**DISTRICT 4 JUNIPER REST AREA  
EASTBOUND AND WESTBOUND REPAIRS**

December 14, 2016  
Requisition #: D00108

**ADDENDUM #1**

# LOCKSET RETROFIT MEASUREMENTS

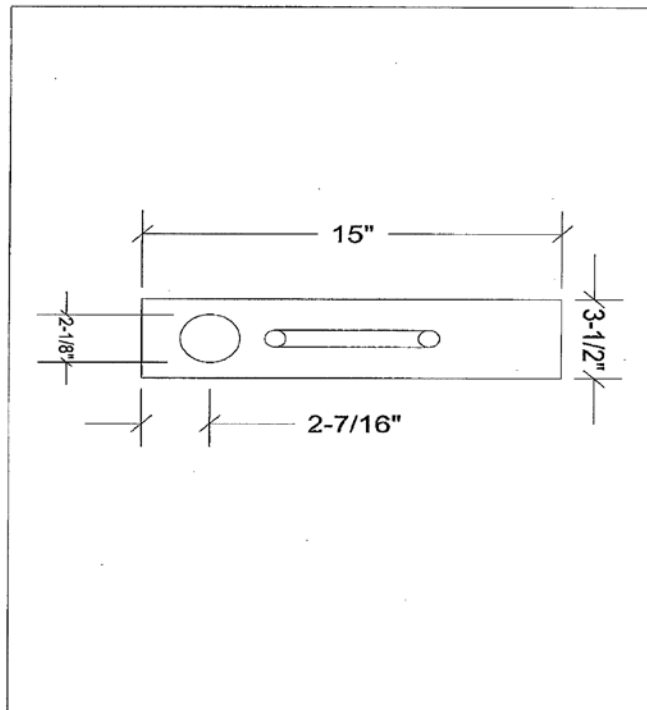
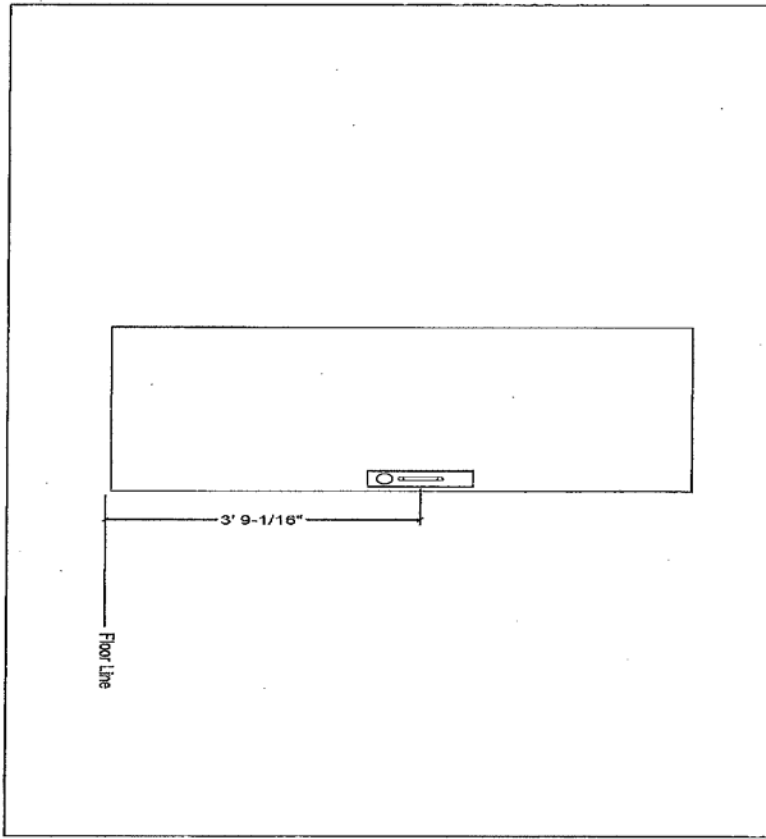
What type of door closer will be required?

See attached specification.

Hydraulic, LCN 4040 PA

# REFERENCE FLOOR PLAN

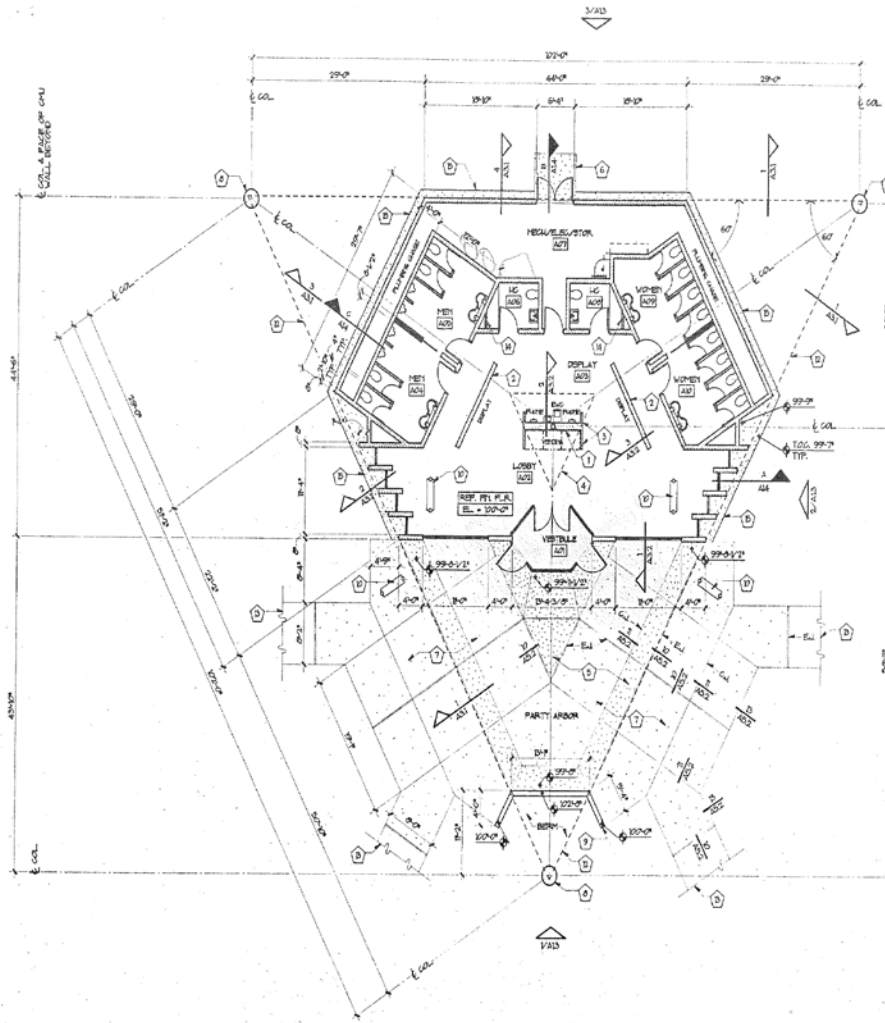
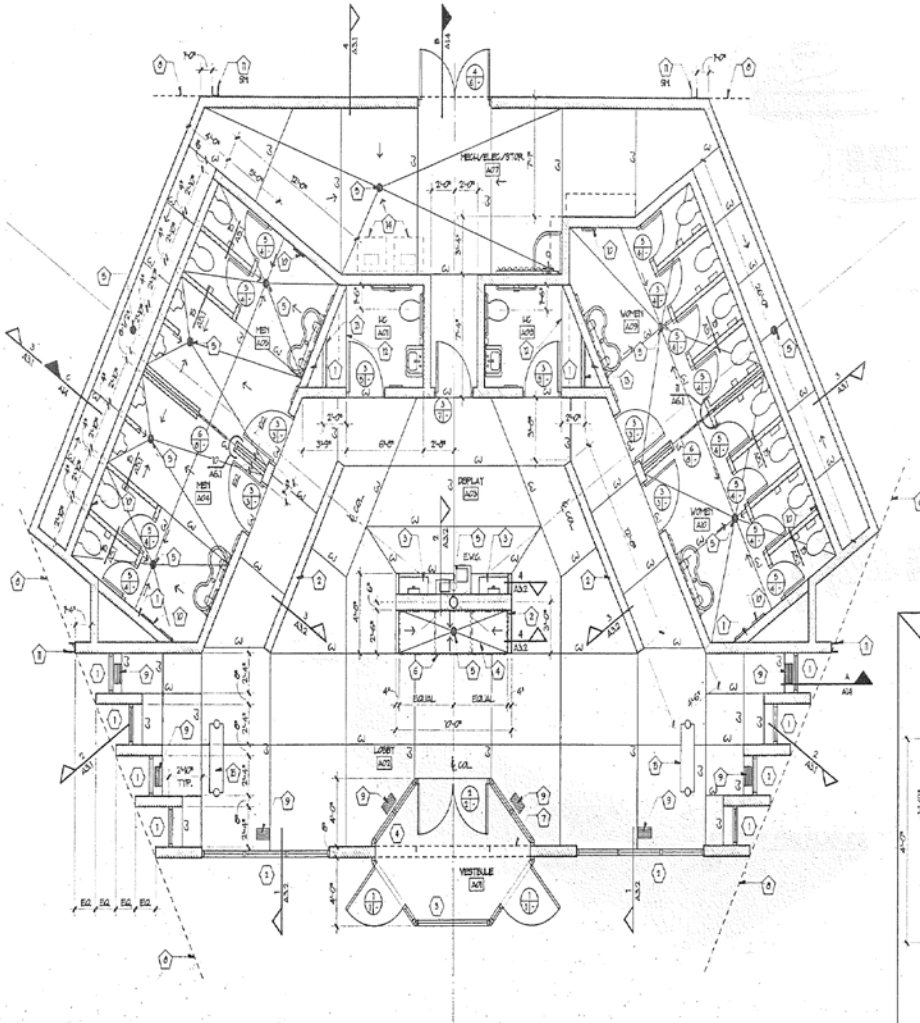
We are wondering if there are a set of blueprints available for our use, to help us with scales and square footages.

See attached floor plans.
